**Enclosure 2**

**Consolidated June 23, 2016 RAI Responses for General Information and Organization & Administration (RAIs 1-12)**

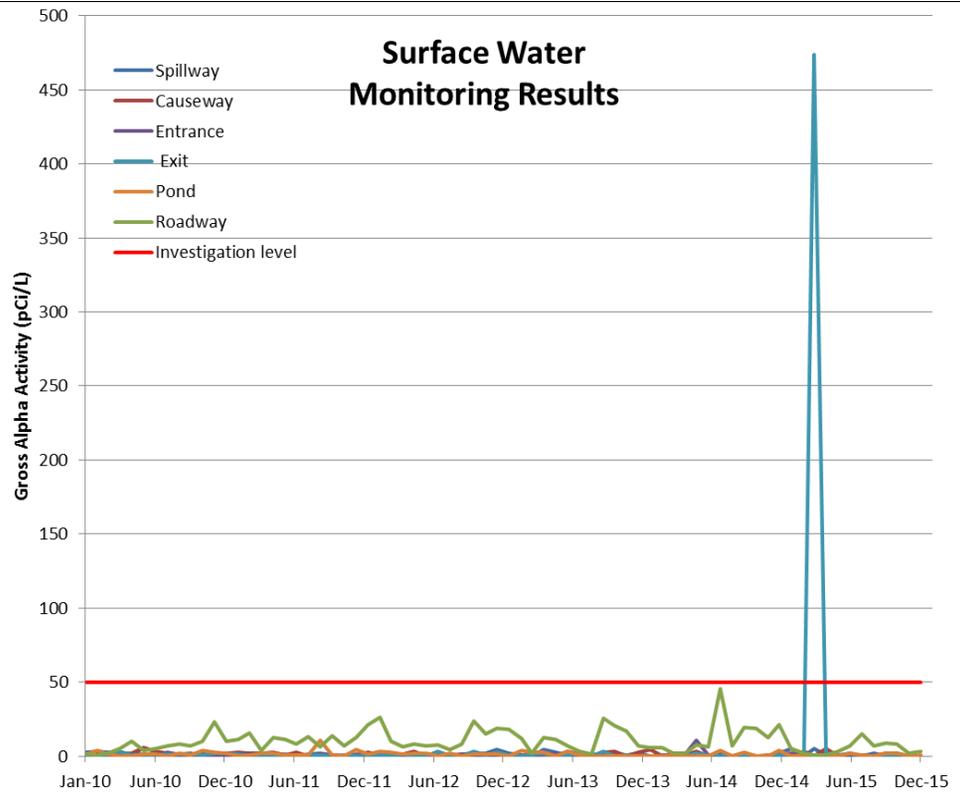
<b>RAI 71</b> Describe all applicable Federal and State standards for discharges and any permits issued by Federal, State, or local governments, for gaseous and liquid effluents.	10 CFR 70.22(a) (8)	See the table provided as Attachment 2 on page 47 of this enclosure.
<b>RAI 72</b> Provide gross alpha monitoring data including exceedances of the maximum contaminant level for ground water and surface water and above	10 CFR Section 51.45.(b)(1), 10 CFR	The maximum contaminant level (MCL) for drinking water is 15 pCi/l, which is the investigation action level for subsequent isotopic uranium analysis at the Westinghouse CFFF per license SNM-1107. Since 2008, the 15 pCi/l MCL has been exceeded six times in NRC wells, as documented in both the table and figure below.

Note only the exceedances are listed below:

Well 7	26 March 2009		
Well 13	17 Sept 2011	18 December 2011	
Well 23	25 Sept 2010	47 November 2010	19 June 2011

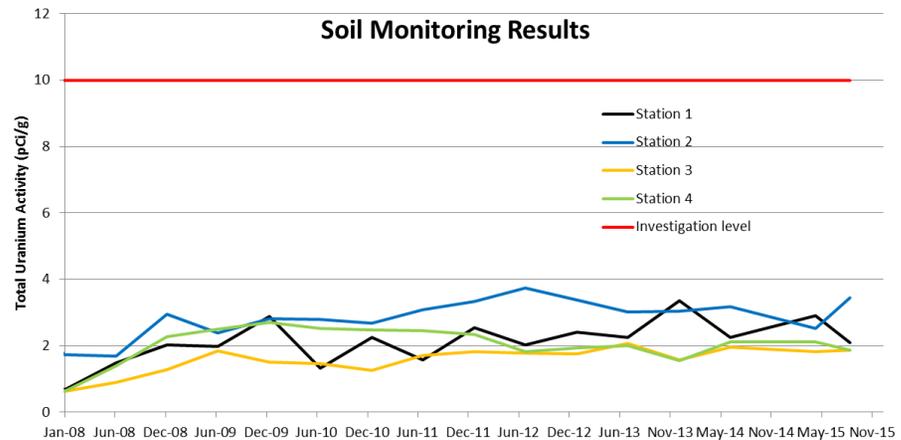
regulatory concern for soil contamination since 2008. Identify the year(s) of occurrence(s), source(s), amount of estimated releases, and location of any gross alpha contamination, and the status of the measures used to identify the source of contamination, and the contaminant elements contributing to the contamination in ground water, surface water, and soil. Discuss ground water and surface water pathways, and the understandings within the conceptual site model of the contaminant plumes, the technical basis of gross alpha contamination to the drinking water sources, potable water wells south of the site, and the environmental impacts on ground water, surface water, and soil resources due to gross alpha contamination for the proposed action and no-action alternative.

For surface water, the investigation action level has been 50 pCi/l. This action level has been exceeded once since 2010. This occurred in March 2015. The alpha result was 474 pCi/l at the "exit" sampling location, as documented in the following figure:
